## DART SERVICE INSTRUCTION

TO AMEND INSTALLATION INSTRUCTIONS IIN-D212-803 REV. D AND INSTRUCTIONS FOR CONTINUED AIRWORTHINESS ICA-D212-803 REV. 3 OR LATER APPROVED REVISIONS

REF. FAA STC: SR02233SE REF. TCCA STC: SH16-34 REF. EASA STC: EASA.IM.R.S.10048356

## 1.0 PURPOSE

FIGURE 1 - Door Modification for Co-Pilot Collective Head Installation OEM LH Crew Door

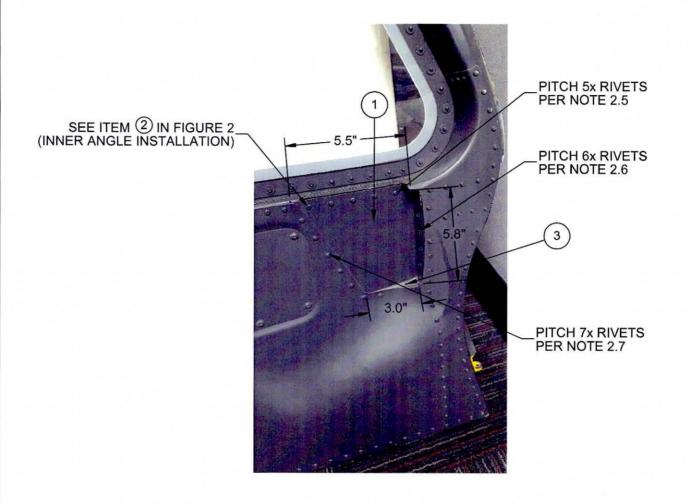
It has come to Dart's attention that because of variations in travel and alignment, the p/n D4410-041/-043/-045, D5046-041/-043/-045/-047 and D5155-041/-043/-045/-047 Collective Heads used in the DXXX-803-XXX LH PIC kits may interfere with the OEM LH crew door at the bottom of their travel.

The purpose of this DSI is to provide instructions for modifying the OEM LH crew door to provide clearance to prevent that possible interference.

- 2.1 Trim inner door skin from the forward rib to the dimensions shown in Figure 1. Take care not to damage rib.
- 2.2 Fabricate a cover (1) from 0.040" thick 2024-T3 aluminum per QQ-A-250/5 to close the inner skin.

- 2.4 Transfer existing 7x Ø 0.129" (#30 drill) rivet holes from the top frame to the new inner angle (2) as shown in Figure 2.
- 2.5 Pitch 5x Ø 0.129" (#30 drill) rivet holes as required, approximately 1.0" -1.1" pitch, from cover (1) to the inner angle (2) as shown in Figures 1 and 2.

- 2.6 Pitch 6x Ø 0.129 (#30 drill) rivet holes as required, approximately 1.0"-1.1" pitch, from the inner door skin into the cover (1) as shown in Figure 1.

- 2.7 Pitch 7x Ø 0.129 (#30 drill) rivet holes as required, approximately 1.0"-1.1" pitch, from the inner door skin into the cover (1) as shown in Figure 1.

- 2.9 Rivet parts (1) and (2) together using CR3213-4 or equivalent rivets.
- 2.10 Seal the gap opening near the bottom of the cover (1) using Pro Seal 890 or equivalent (3).
